TECH-25004-CTE17-4.2

Proposal for the revision of the Uniform Technical Prescription applicable to the accessibility of the rail system for persons with disabilities and persons with reduced mobility

UTP PRM

TECH-25004 Annex 1

Figure G1 Horizontal array set up

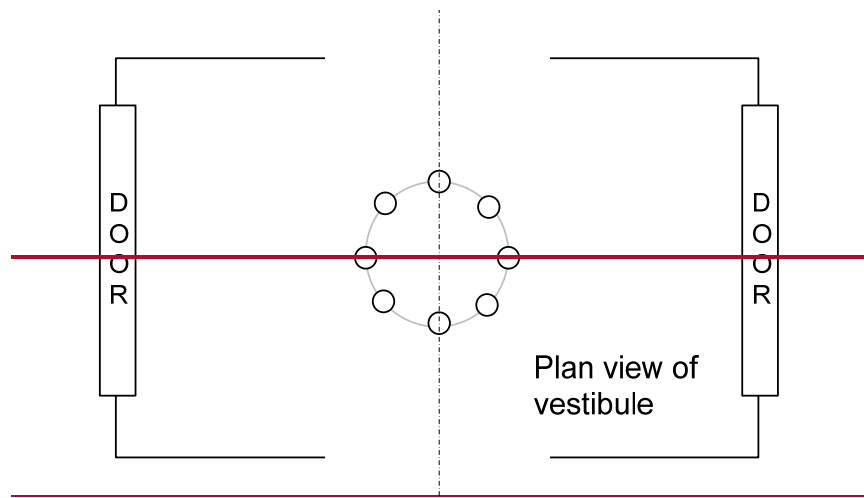
| Appendix G – door opening and closing signals | Appendix G – door opening and closing signals | Change of measuring method |

~~Figure II—Wheelchair space in facing seating arrangement~~

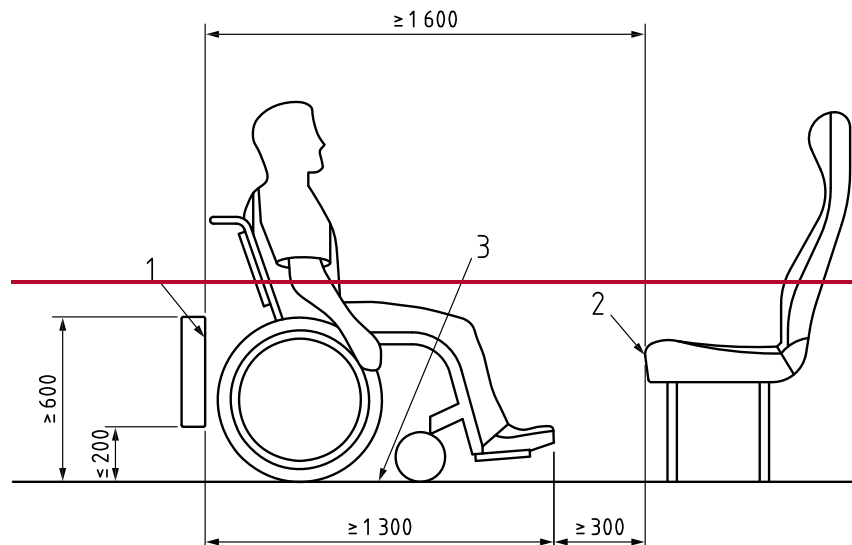
APPENDIX I:

not used

~~Diagrams of wheelchair spaces~~

- (4) The minimum distance in the longitudinal plane between the back of the wheelchair space and the next surface shall be in accordance with [the specification referenced in Appendix A, Index \[16\] Appendix I, figures I1 to I3](#).

FIGURE I4 – TWO ADJACENT WHEELCHAIR SPACES (APPLICABLE TO UPGRADED/RENEWED ROLLING STOCK ONLY)

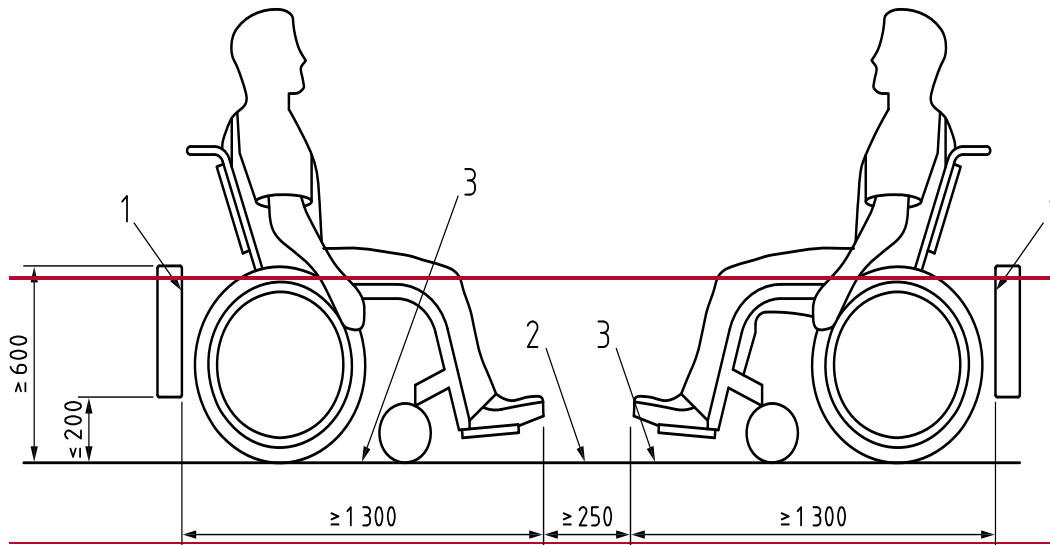
The provision of wheelchair spaces is only required when the seating layout is altered within a complete train formation. However, if the entrance doorway, or clearways, cannot be modified to enable wheelchair access, a wheelchair space ~~does not need~~ ~~not to~~ be provided if the seating layout is altered. Wheelchair spaces created in an existing rolling stock ~~are permitted to~~ ~~may~~ be arranged ~~in accordance with the specification referenced in Appendix A, Index [16]~~ ~~to Appendix I, figure I4~~.

The provision of wheelchair spaces is only required when the seating layout is altered within a complete train formation. However, if the entrance doorway, or clearways, cannot be modified to enable wheelchair access, a wheelchair space does not need to be provided if the seating layout is altered. Wheelchair spaces created in an existing rolling stock may be arranged in accordance with the specification referenced in Appendix A, Index [16].

~~Figure J1—Minimum clearway width from floor level to a height of 1000 mm~~

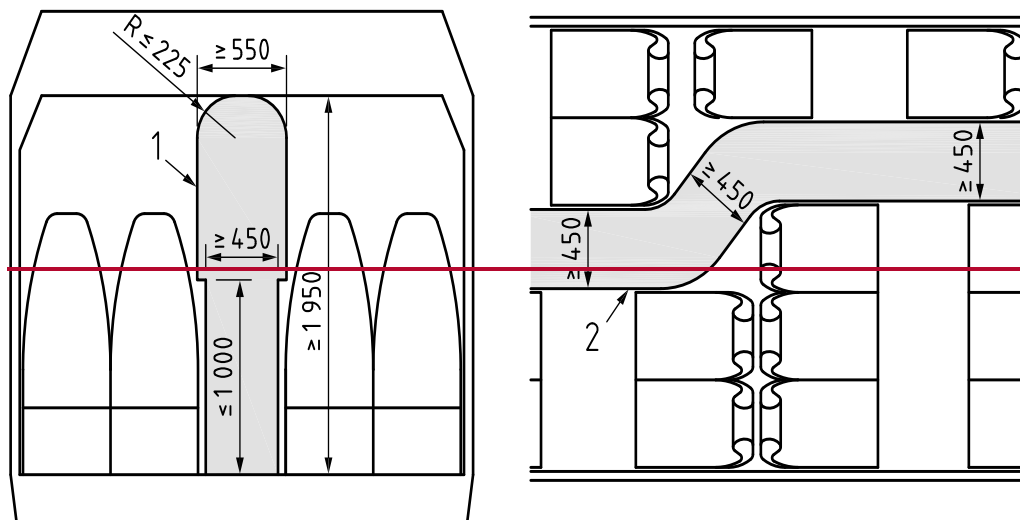
Appendix J:

not used ~~Diagrams of clearways~~

- (1) From the vehicle entrance, the following section of the clearway shall be in accordance with the specification referenced in Appendix A, Index [17] ~~as follows:~~
 - through the vehicles ~~according to figure J1 of Appendix J,~~
 - between connecting vehicles of a single trainset, ~~according to figure J2 of Appendix J,~~
 - to and from wheelchair accessible doors, wheelchair spaces and wheelchair accessible areas including sleeping accommodation and universal toilets if provided, ~~according to figure J3 of Appendix J.~~
- (2) The minimum height requirement does not need to be verified in:
 - all areas of double-deck vehicles,
 - gangways and door areas of single deck vehicles.
